Rockwell service letter No. SL-AG-51

Service Letter No. SL-AG-51
February 1, 1969

RE-POSITIONING OF VOLTAGE REGULATOR ASSEMBLY

APPLICABILITY: ALL S-2R Aircraft, Serial Number 1416R through 1460R.

SHEET 2 of 3

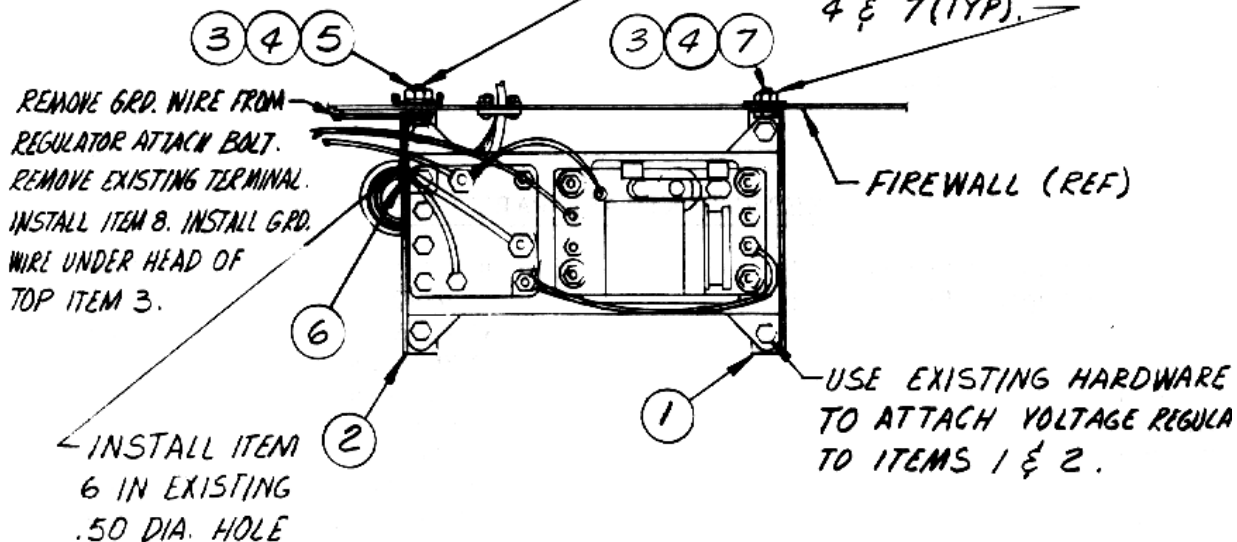
The voltage regulator on S-2R's Serial 1416R through 1460R is mounted in a vertical position on the firewall. There have been field reports that indicate that a longer regulator life could be obtained by mounting it in a horizontal position. By changing the position of the regulator, the shock mounts are more effective and should prolong the regulator life during operations on rough strips.

REMOVE VOLTAGE REGULATOR ASSY FROM FIREWALL. REMOVE 3 EXISTING RIVETS BETWEEN EXISTING .25 DIA. HOLES. ALIGN TOP & BOTTOM HOLES IN ITEM 2 WITH EXISTING .25 DIA. HOLES IN FIREWALL. DRILL FIREWALL .25 DIA. TO MATCH 2 MIDDLE HOLES IN ITEM 2. INSTALL ITEMS 3, 4 & 5 (TYP).

ALIGN TOP & BOTTOM HOLES IN ITEM 1 WITH EXISTING .25 DIA. HOLES IN FIREWALL. DRILL FIREWALL .25 DIA. TO MATCH 2 MIDDLE HOLES IN ITEM 1. INSTALL ITEMS 3, 4 & 7 (TYP).

SHEET 3 of 3

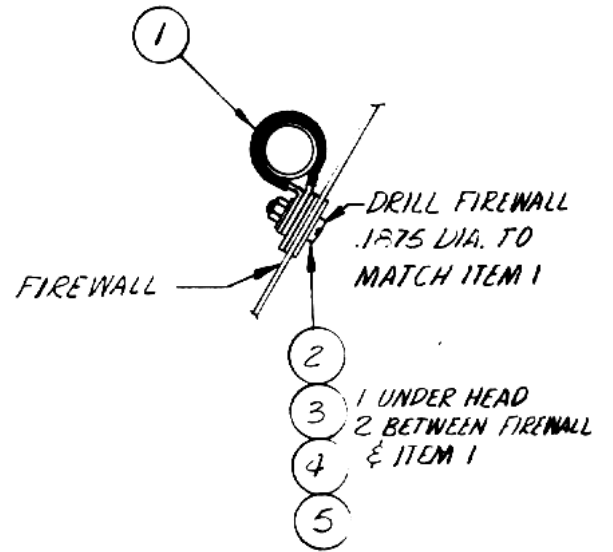
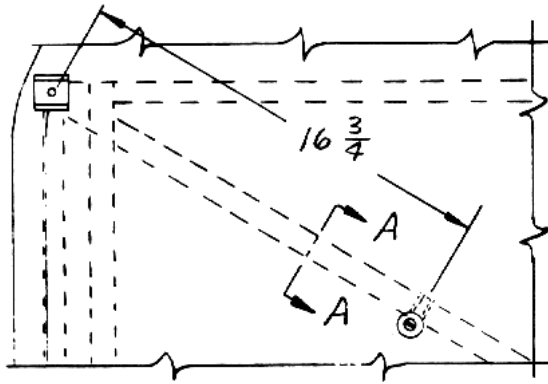
At the same time the voltage regulator assembly is re-positioned, a firewall clamp should be added for additional firewall support. This installation is shown on Sheet 3. Instructions for re-positioning the voltage regulator are called out on Sheet 2.
